ONSITE SEWAGE DISPOSAL SYSTEM DESIGN PLAN

FULTON MANOR VALLEY - LOT 9
 12159 FULTON ESTATES COURT
 FULTON, MD 20759

MEMORANDUM

RE: 12159 Fulton Estates Court
Fulton, MD 20759
"OSDS Plan"

PROFESSIONAL CERTIFICATE

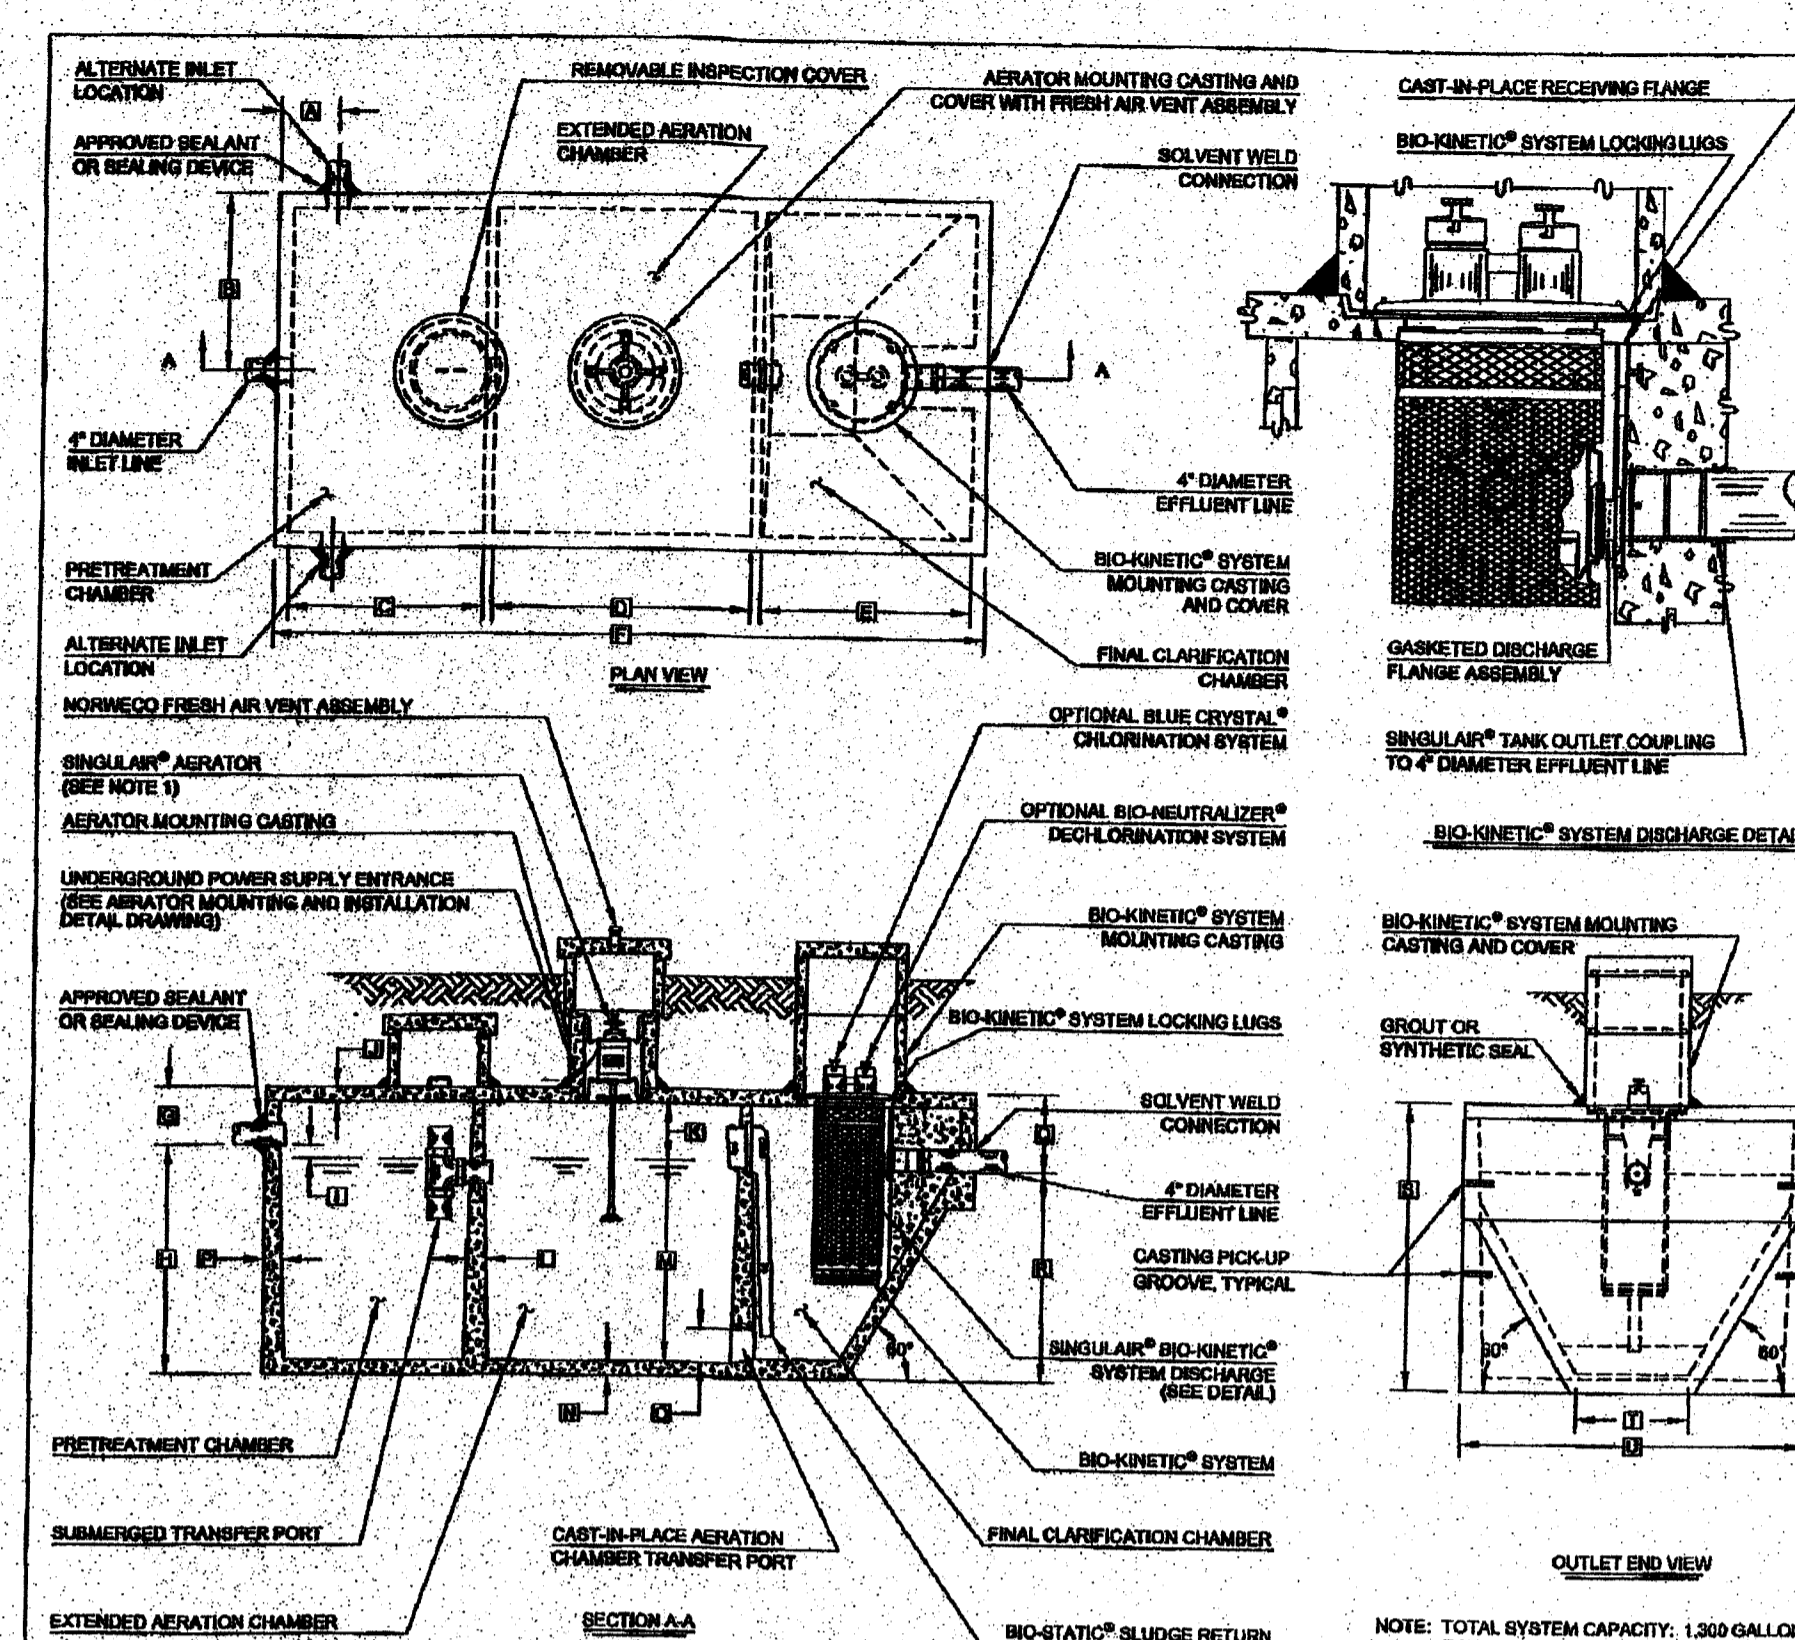
Attached are the computations that you asked for concerning the Fulton Manor Valley lot 9 BAT plan. I am pretty sure the pump specs were shown on the plan under the detail. They are however pretty small. They are also on the attached sheet. Let me know if you need anything else.
